POST AUDIT REPORT

**Aditi Mahavidyalay
New Delhi**

Sugamya Bharat Abhiyan
(Accessible India Campaign)

Aditi Mahavidyalay, Delhi

Route with tactile

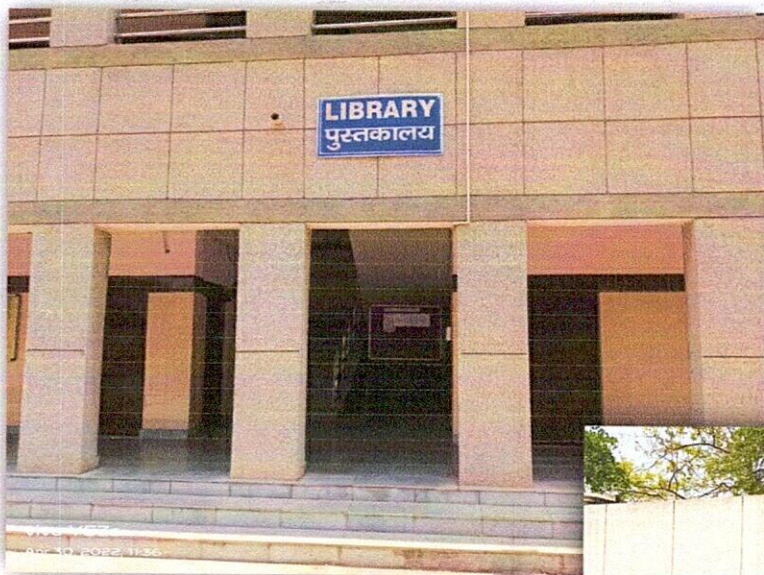
The office is accessed by one main gate meant for vehicular and pedestrian entry and exit. There is a security post at the main entrance gate. There is a pedestrian walkway in the office that is separated from the vehicular roads. Now the road is accessible for visually impaired people with a tactile path. But still, we found some broken holes that can be repaired, as well as signage and some places where tactile paths are missing.

Inaccessible reception counter

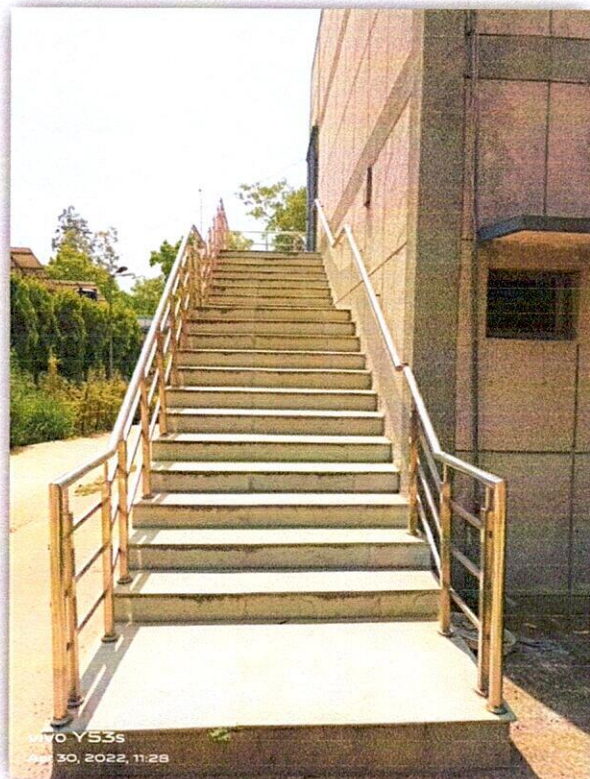
There is particular accessible reception counter at the entrance. There is no signage that leads to the reception and hence-forth to various building facilities. Also missing signage of department / unit name. The office also does not have Audio-Induction Loop and Accessible Printed Information for people with disabilities. There is no live assistance available at the counter to guide people to their destination. None of the staff are trained to communicate in Indian Sign Language.

Counter height 1100mm with no toe and knee space

Note. Make reception counter as per audit report

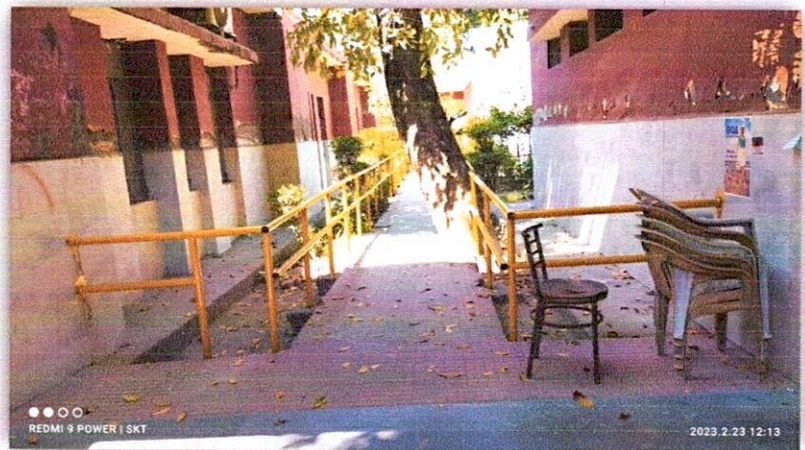
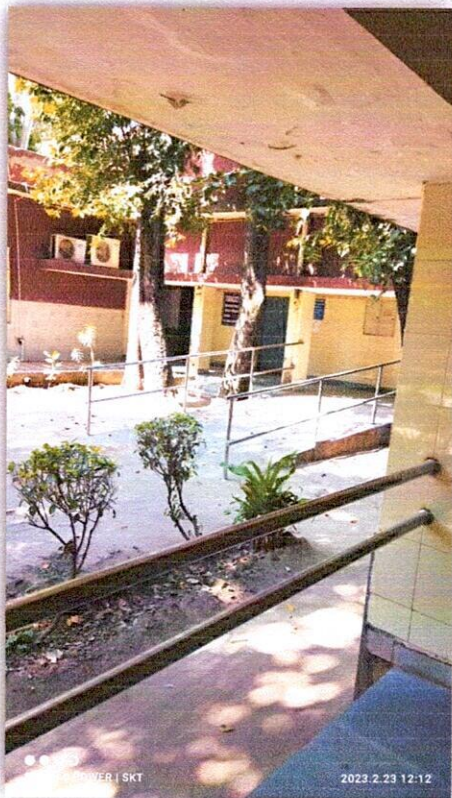
There is no emergency evacuation provision in the building. The building does not have any visual or audible alert system, nor is there any designated refuge area for persons with disability. Also, any kinds of emergency evacuation signage are.

Note: Emergency Evacuation system plan per audit report.

Doorways

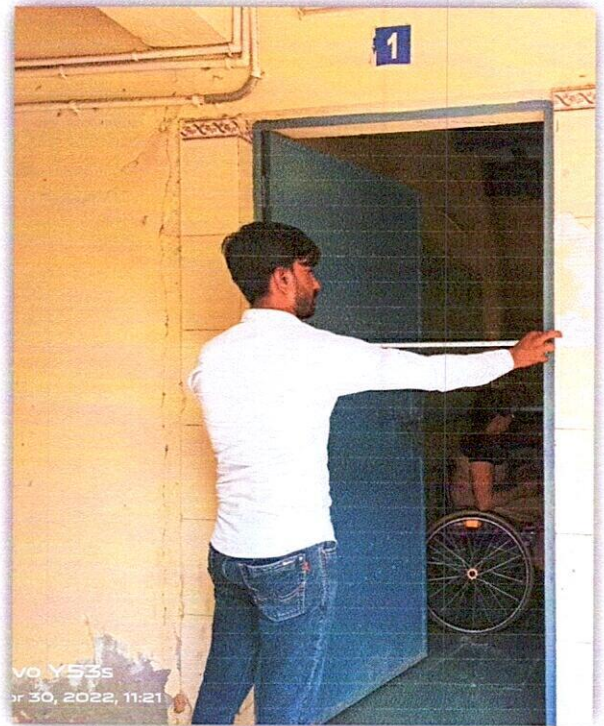
Some doors in the building not maintain a minimum of 1000mm opening. They are easy to operate and do not require a lot of effort. The building has single-hinged doors, which are push type doors which swing one way. Door handle height is 950mm. Doors open inward from the corridor including most of the toilet doors. All doors, doorframes, door furniture contrast in colour with the background wall. The doors do not have timed-release spring for shutting. All the doors are manual. There is sliding doors in toilet. Most doors have not enough space like toilet for a wheel chair user to operate it without any difficulty.

Note: make doors as per audit report

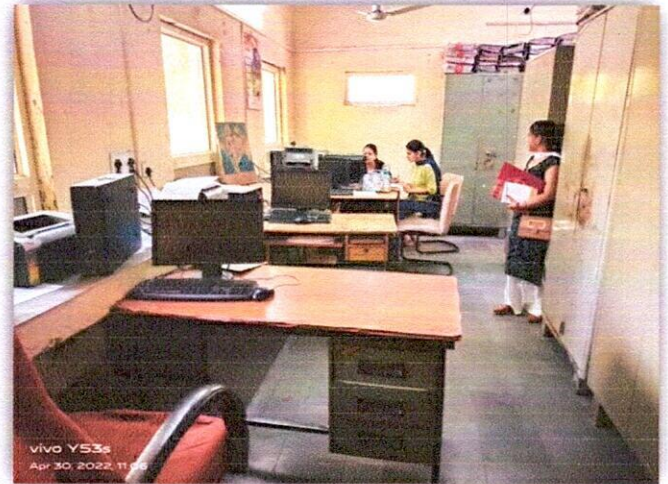
We found inaccessible drinking water facility with two steps

Note: make changes as per audit report

Furniture in different place

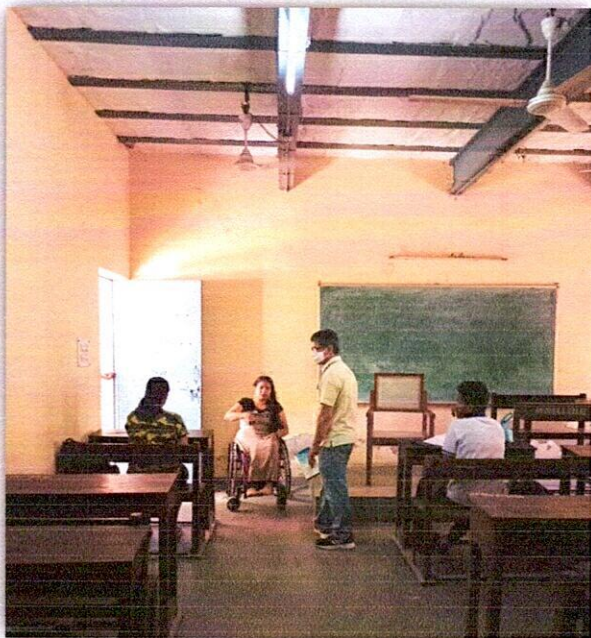
The furniture of different places was not according to the accessibility guidelines. (Table height 760 mm) some table with no toe and knee space, Circulation space in office was good. Switch board and thumb machine variable heights is 1100-1400mm.

Note: make changes as per audit report
